Access Compliance Report Public Rights-of-Way (Curb Ramps)

Main Street: THALIA_ST Cross Street: ARTISAN_ST Location: NW

ADA ID: RPRK211020165310 Ramp Type: Type 1 - Perpendicular Initial Pass/Fail: Fail Overall Compliance: No Severity Score: 2

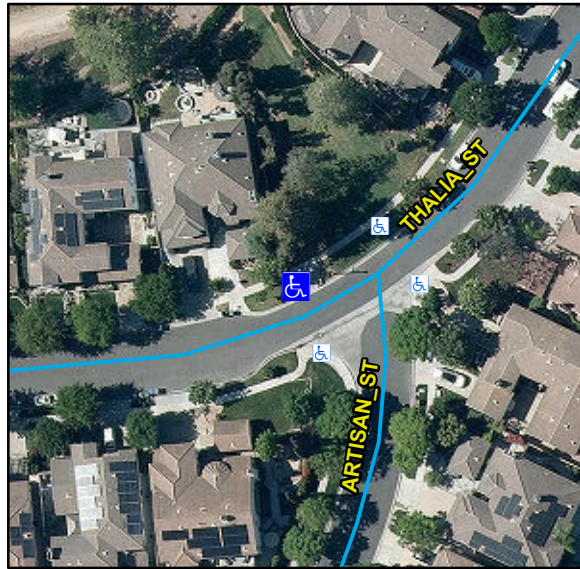
R204.3, R304.5.3, STD 1115

Remove & Replace Entire Ramp.
